ADDENDUM #1

Date Issued:	Jan 19, 2026
Project:	Intermountain Health Layton Hospital Pathology Lab and Locker Room Remodel 201 W Layton Parkway Layton, Utah 84041
Addendum Number:	1

Electrical Addendum #1

Demolition Floor Plan Level 2 - Enlarged

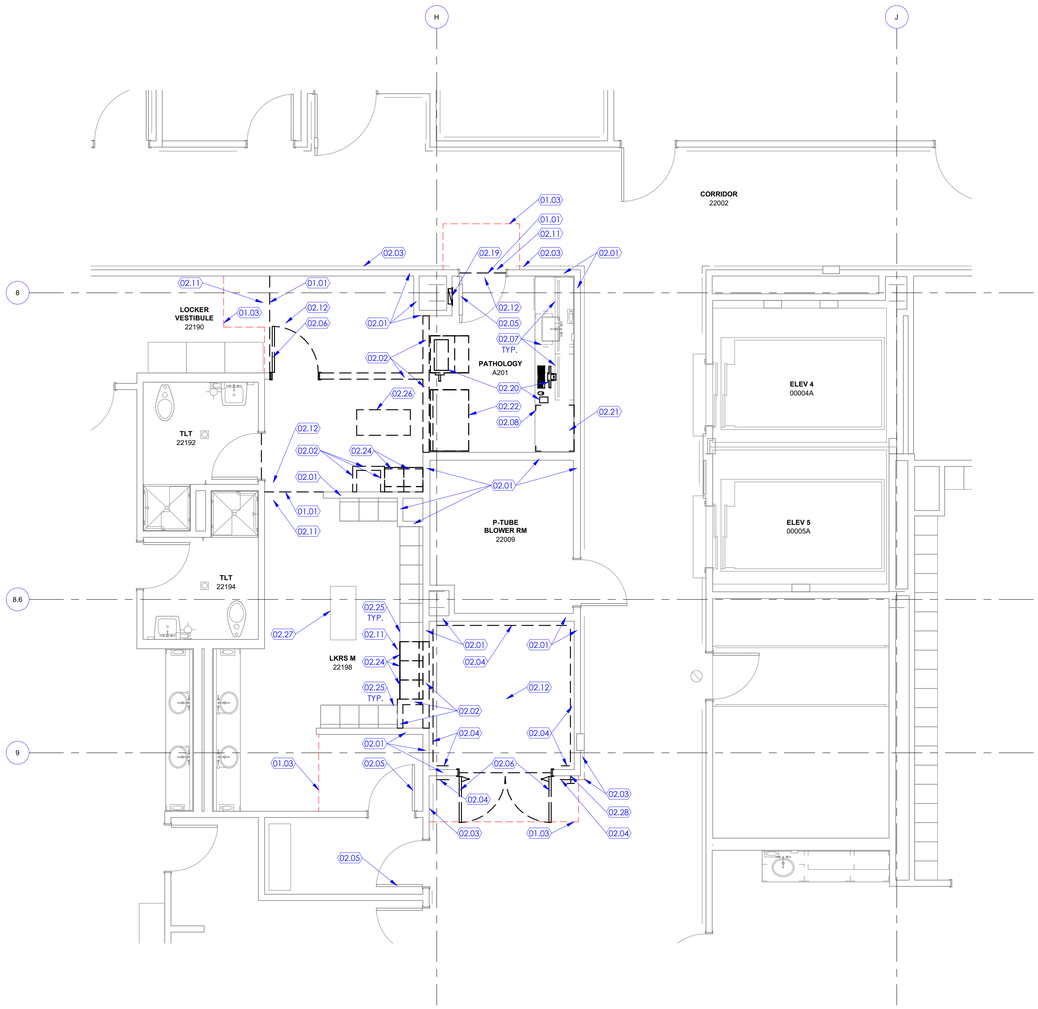
4	Question 4: This panel is being called to be removed. It appears to be serving the existing grossing table. Do these parts need to be returned to the hospital? Also will the new grossing table need a panel for it? Re: Sheets A121 note 2.19 EDP101 Response 4: Yes, the LX panel and components to be returned to owner. They will not be needed for new grossing table connection.
5	The ICRA level for this project has been changed to Level 5. This requires the containment to extend to deck if ceiling tiles are being removed.
6	This project will not be phased. The entire area of the project will be available for the duration of the project.

Sheet Number	Drawings
Architectural Drawings	
G002	ICRA portion updated to reflect Level 5. Drawing index updated to remove sheet A111.
A111	Sheet removed from set as this project will not be phased.
A121	Added note: "NOTE: RELOCATE MEN'S LOCKER ROOM TO STAFF BREAK ROOM LOCKERS FOR THE DURATION OF CONSTRUCTION."
Electrical Drawings	
EE501	Detail added.

8 SINGLE DOOR ROUGH IN DETAIL TYPICAL

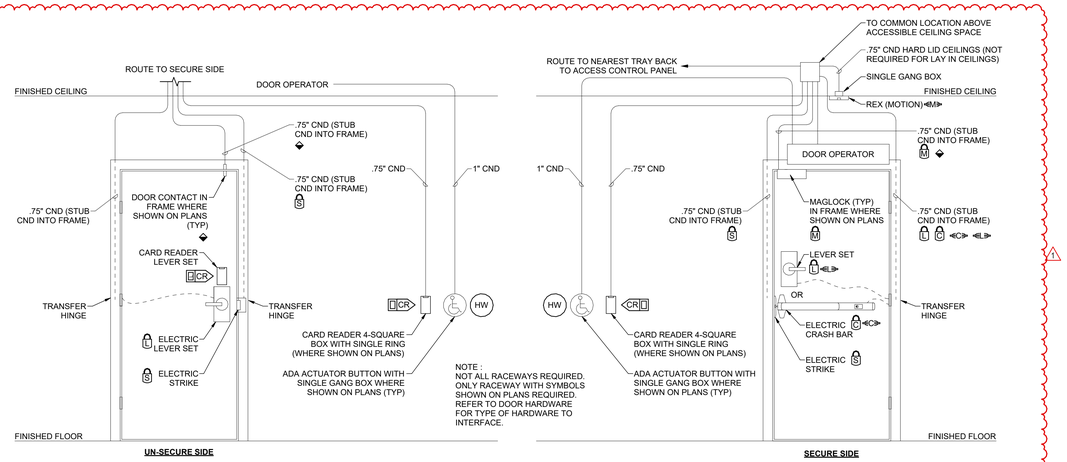
1. EE501:
    a. Added typical single door rough-in detail showing ADA push plate rough in.

Item Number	General Items Description
1	Question 1: It has come to our attention that the Siemens fire alarm devices are no longer being made. Will there be added testing required for different modules for the new devices. Response 1: That is correct. The current modules supporting the system at Layton Hospital are now listed as obsolete. This will require the procurement of a newer model module, Siemens to update the software to work with that new model, and retest of a portion of the entire system. We would ask that all bidders consider the costs associated with this process.
2	Question 2: Sheet M223. Does the relocated VAV VR-A2-85 need mechanical piping? Size? Response 2: The relocated VAV VR-A2-85 is cooling only and requires no mechanical piping.
3	Question 3: Drawing EP101 indicates (2) "HC" designations for ADA push button rough in. There is no detail provided for this scope. Should we just include a stub to accessible ceiling? What is "LX" on the electrical ceiling demo sheet? Response 3: They will need to provide a rough in and push plates for that door. Drawings to be updated to show the push plate detail. See attached Electrical Addendum #1.
